C1991x MAIN FIRMWARE RELEASE NOTES

Uni-7 Series with PK-260A CPU Board

C1991x continues from B0674R as the standard Uni-7 firmware for the PK-260A CPU board.

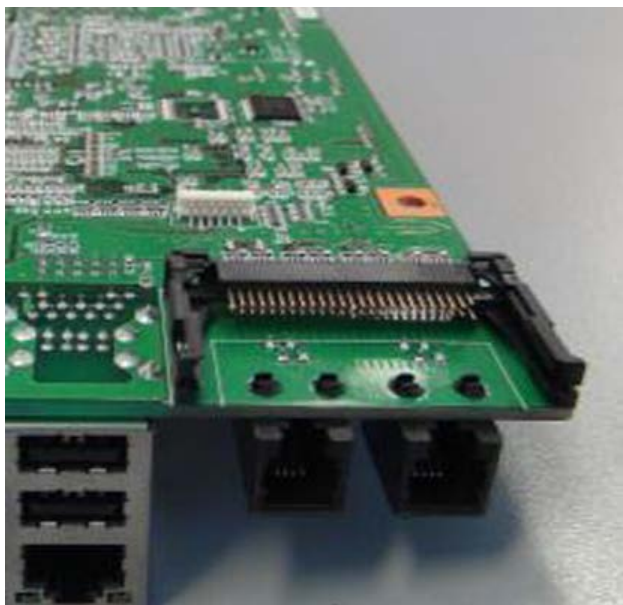
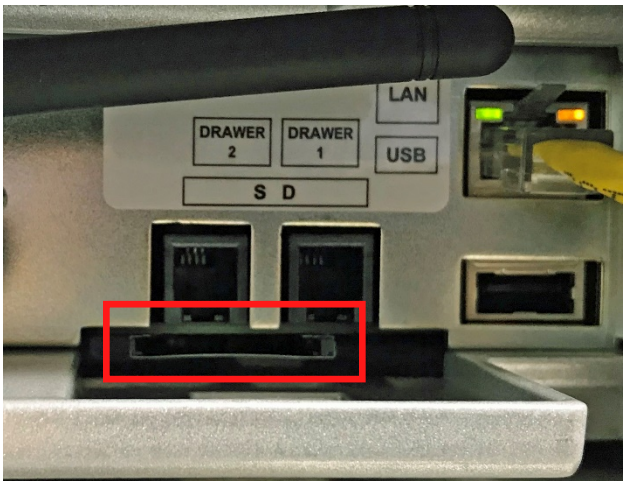
Firmware C1991x is designed for the original CPU board PK-260A. **This firmware is not compatible with the revised CPU board PK-260B.** And new firmware (C2032x) is not compatible with the original PK-260A CPU board.

The two CPU board versions can be easily identified by the expansion memory card slot located on the left side of the Uni-7. See the images on the next page.
